2023 Addams Fence and Gate Replacement Project

No. 0003-23-24

ADDENDUM #1

Date Issued: October 20th, 2023

Jane Addams Middle School

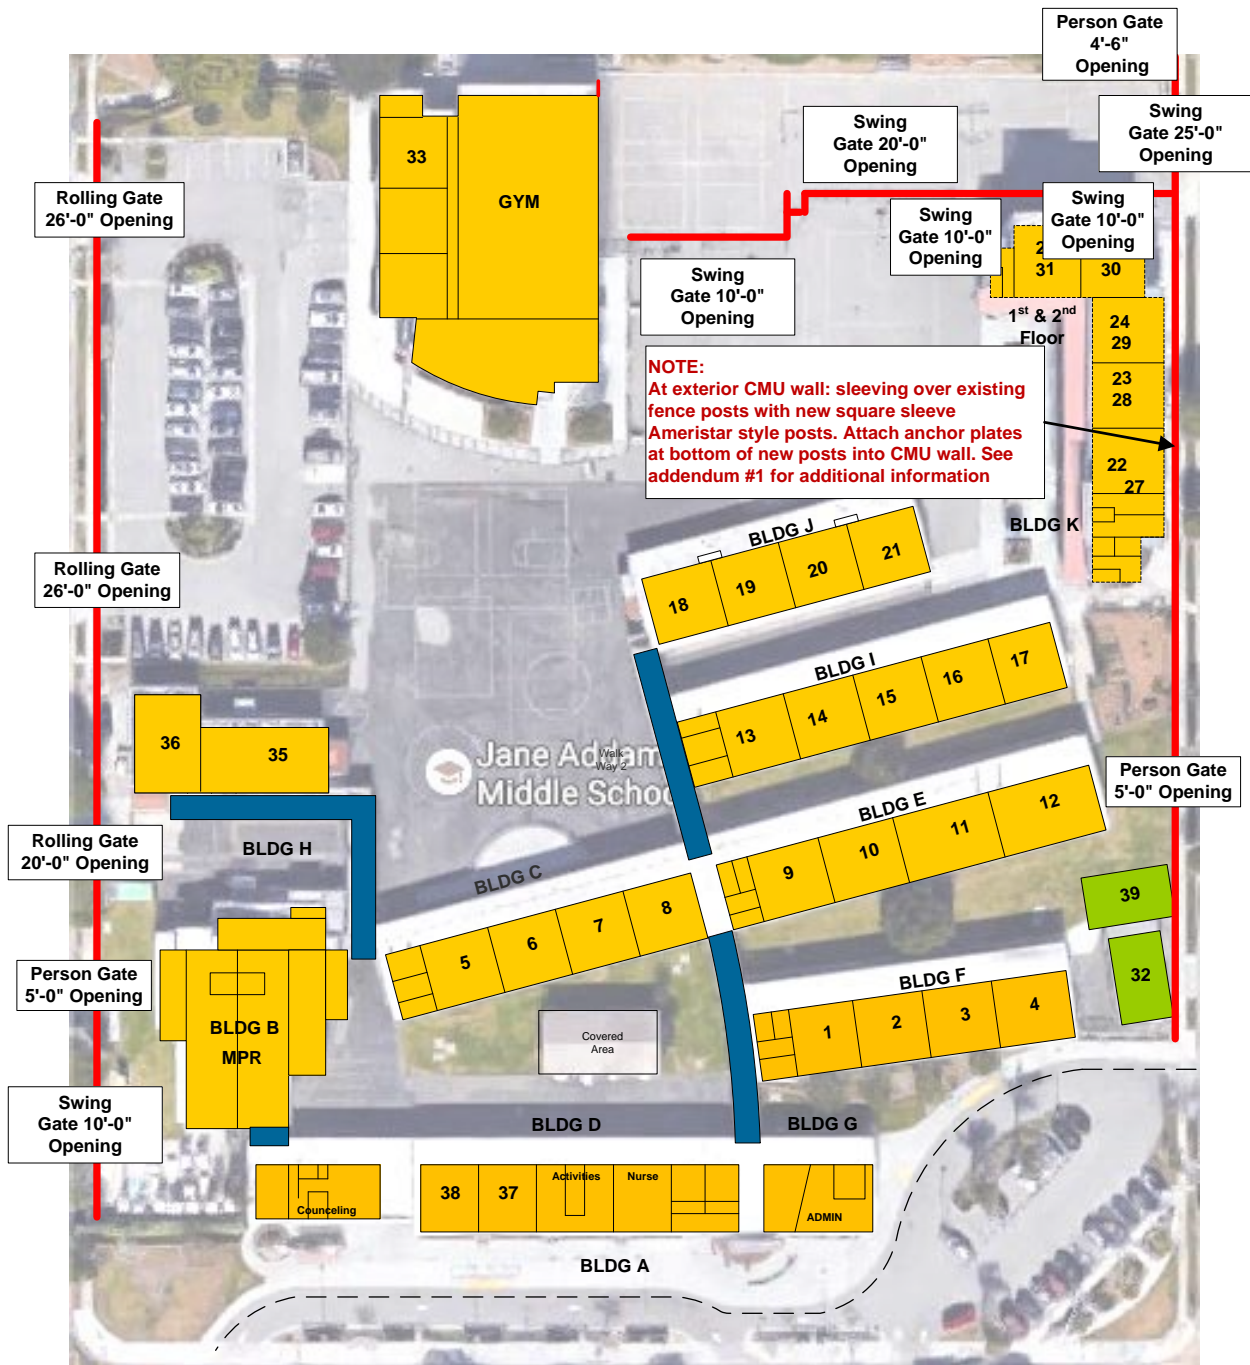
Item B – Revised Scope of Work and Site Plan

Scope of work has been revised; additions and clarifications are in red. Revised site plan is also included in this addendum.

Based on the scope of work sheet provided last week, will the fencing only include the work area clouded on the scope of work sheet or will it also include the others areas walked during the job walk meeting? I have attached both sheets for your review. Please clarify.

See site plan included in this addendum. Scope of work as per the job walk, the updated scope, and the updated site plan.

**Contractor to field
verify all data.
Dimensions are post-to-
post opening sizes.**
